**Planned Development District
General Implementation Plan Amendment
Zoning for Lot 27 First Addition to
Fitchburg Technology Campus, and
Lot 3 CSM 11600**

**ORDINANCE NO. 2014-O-09
ZONING ORDINANCE AMENDMENT
AMEND GENERAL IMPLEMENTATION PLAN ZONING
FOR LOT 27 FIRST ADDITION TO FITCHBURG TECHNOLOGY CAMPUS
AND LOT 3 CSM 11600**

Re: Rezoning and CSM Submittal – Responses to City Comments
The Madison Group Headquarters, City of Fitchburg

OVERALL SITE PLAN

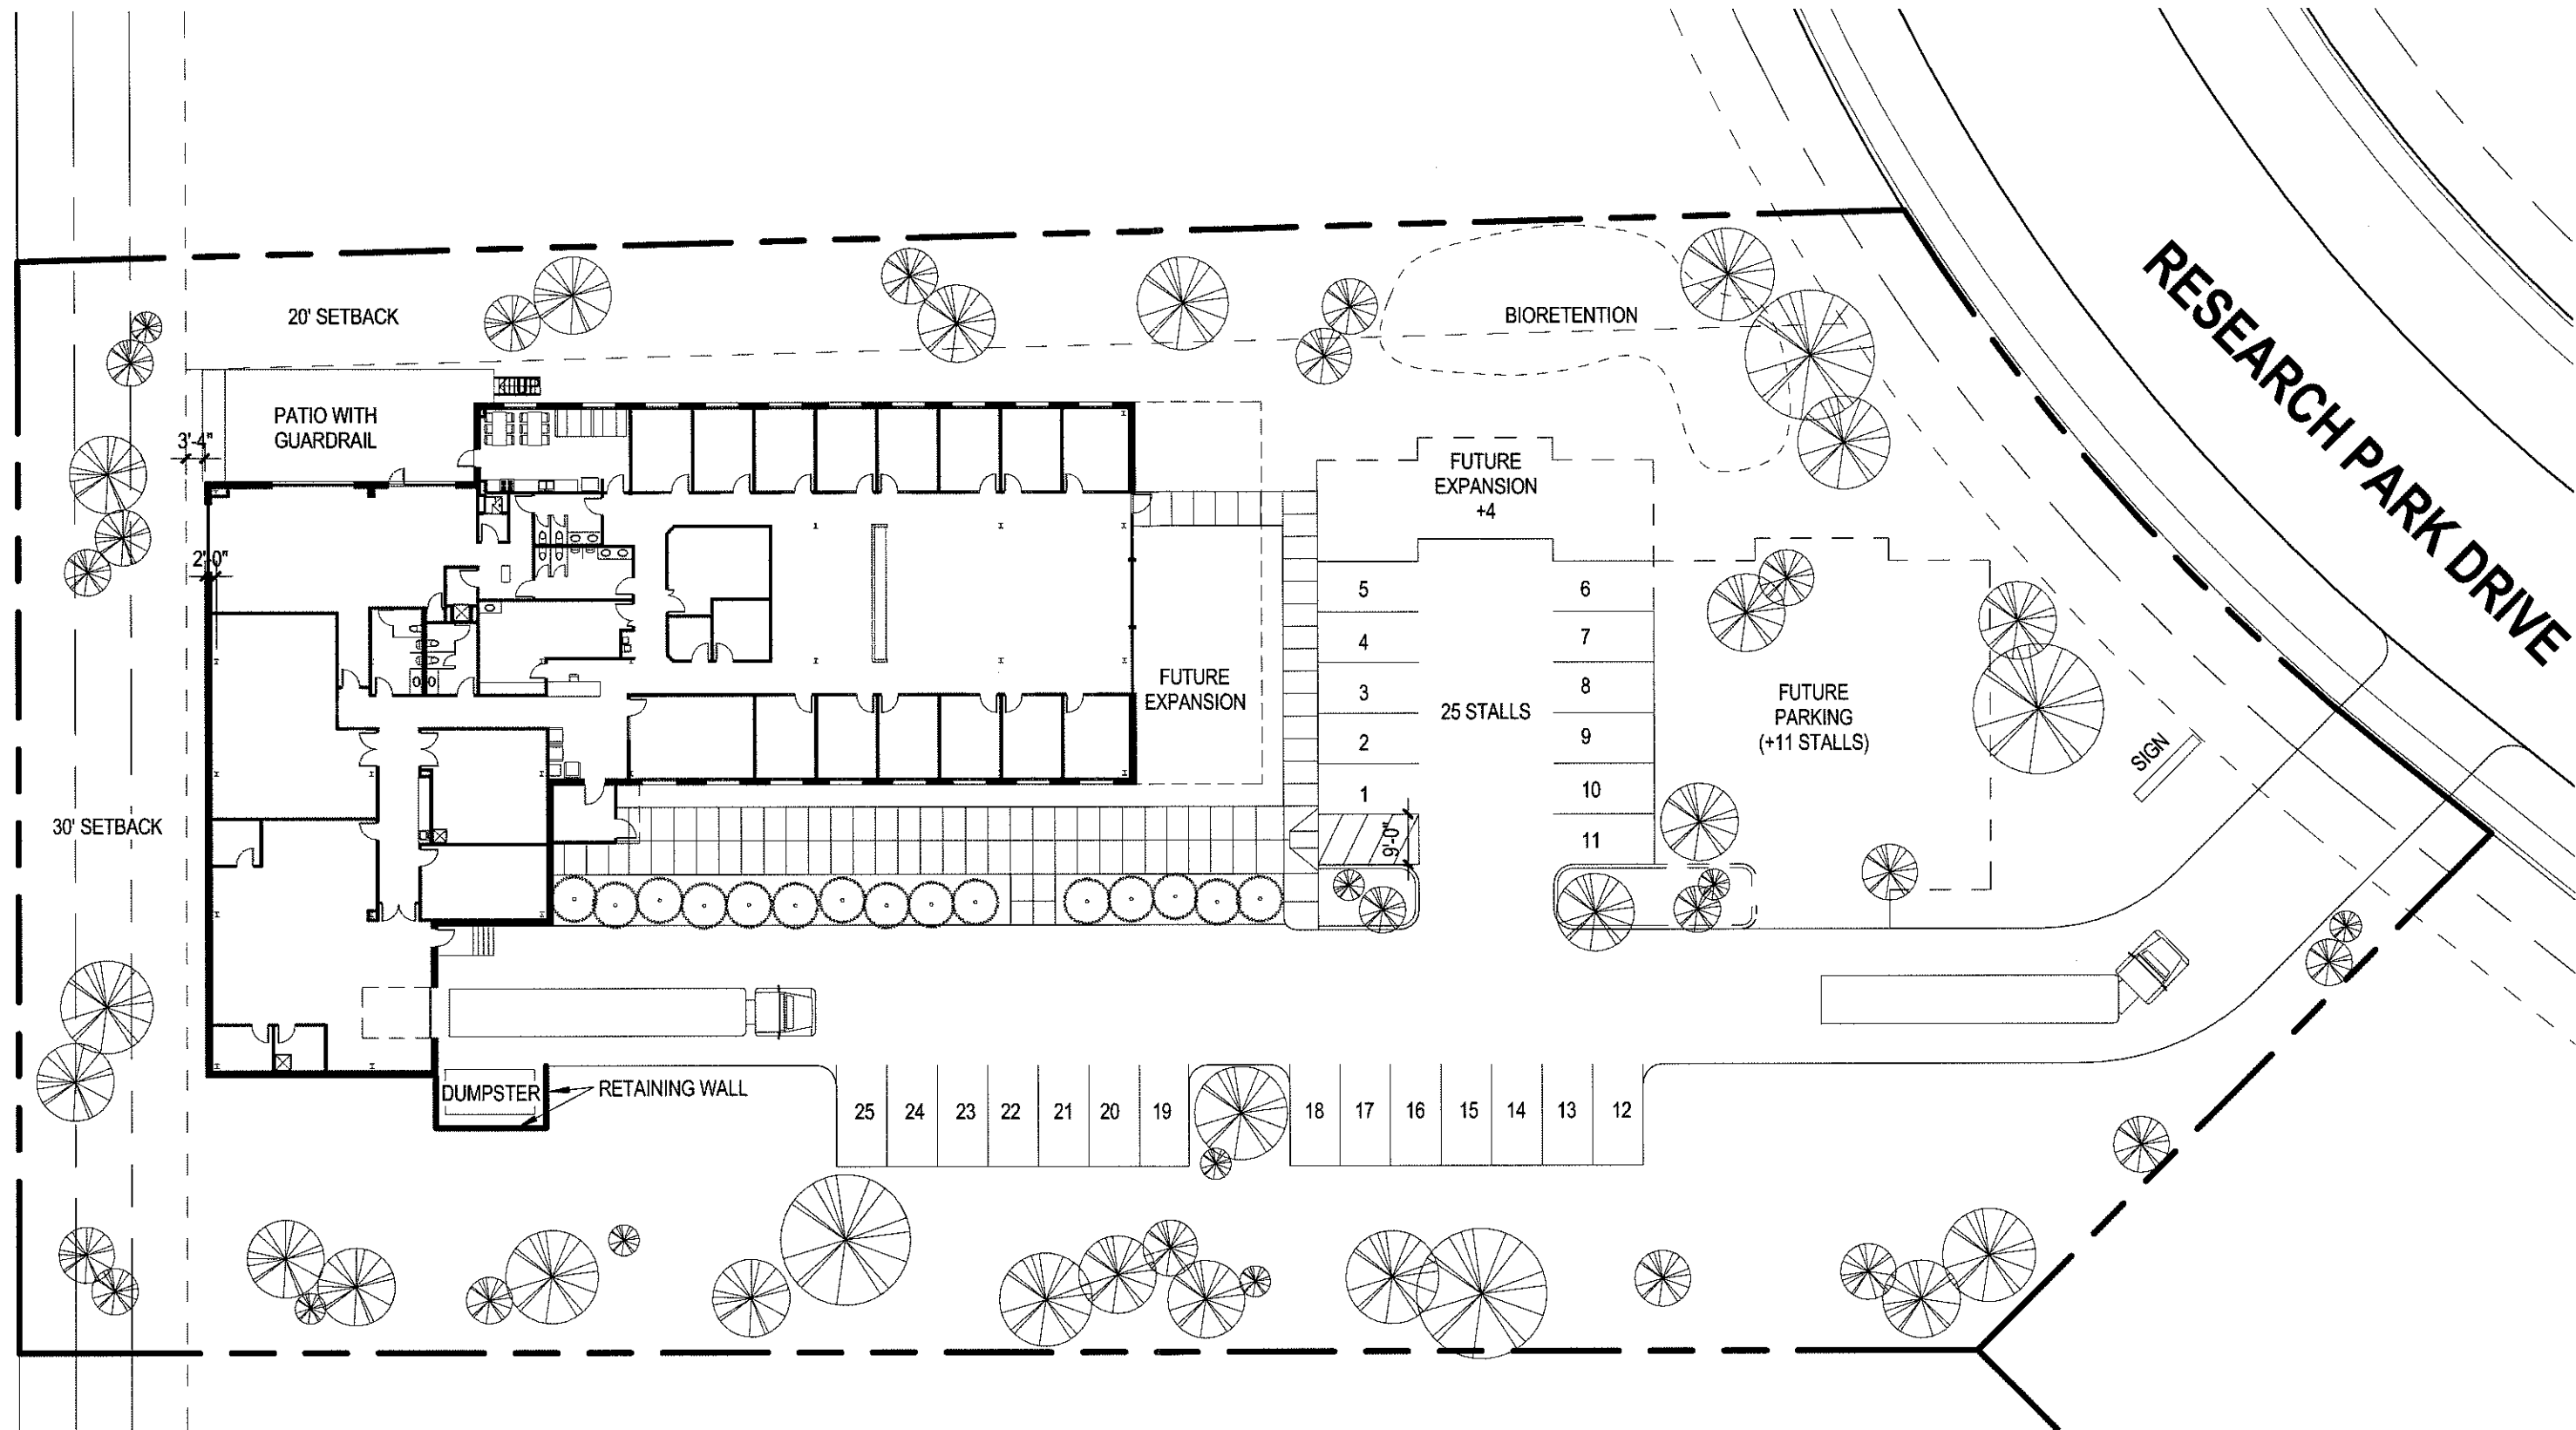
1. On the overall site plan they indicate a Combined FAR as 13%. I calculate it as 41.7% (71,000/170,215).
Applicant Response: For the overall site, 41.7% is correct. The 13% is in reference to The Madison Group's portion.

2. They should retitle the upper right text block (currently titled Approximate Remaining Site Data) to read "Approximate Site Data for Sites A and B." The North site should be labeled on the site as "Madison Group Site".
Applicant Response: Will comply
